VIRGINIA ELECTRIC AND POWER COMPANY
RICHMOND, VIRGINIA 23261

Serial No. 16-146A
NLOS/GDM R3
Docket No. 50-281
License No. DPR-37

VIRGINIA ELECTRIC AND POWER COMPANY
SURRY POWER STATION UNIT 2
ASME SECTION XI INSERVICE INSPECTION PROGRAM
RELIEF REQUESTS FOR LIMITED COVERAGE EXAMINATIONS
PERFORMED IN THE FOURTH 10-YEAR INSERVICE INSPECTION INTERVAL
RESPONSE TO REQUEST FOR ADDITIONAL INFORMATION

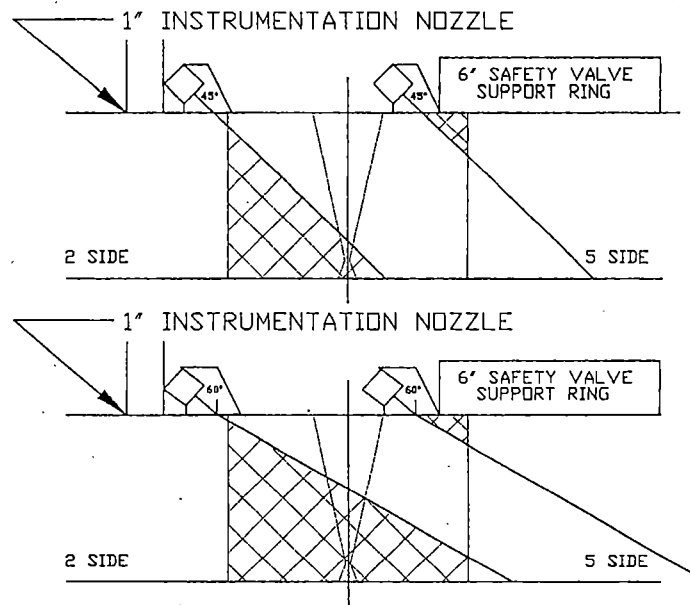
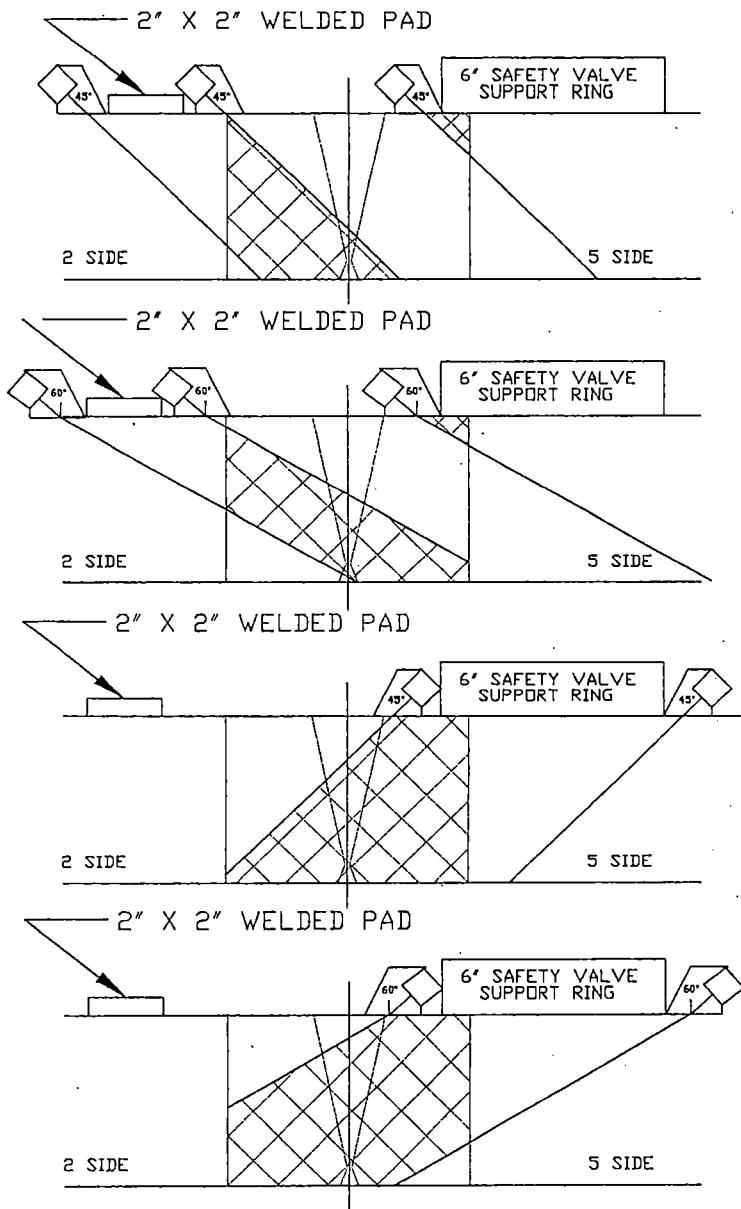
With respect to relief request LMT-C02, please clarify that the obstructions are the two beams of the insulation support frame as depicted in pages 4 and 5 of Attachment 6 "Relief Request LMT-C02, Examination Category B-D, Pressurizer Inner Radius Section" of the licensee's submittal. In addition, please state whether recordable indications were detected in the 80% volumetric coverage of 14NIR that was achieved.

The obstructions are the two beams of the insulation support frame as depicted in pages 4 and 5 of Attachment 6, "Relief Request LMT-C02, Examination Category B-D, Pressurizer Inner Radius Section," included in our May 5, 2016 letter. There were no recordable indications detected in the 80% volumetric coverage of 14NIR that was achieved.
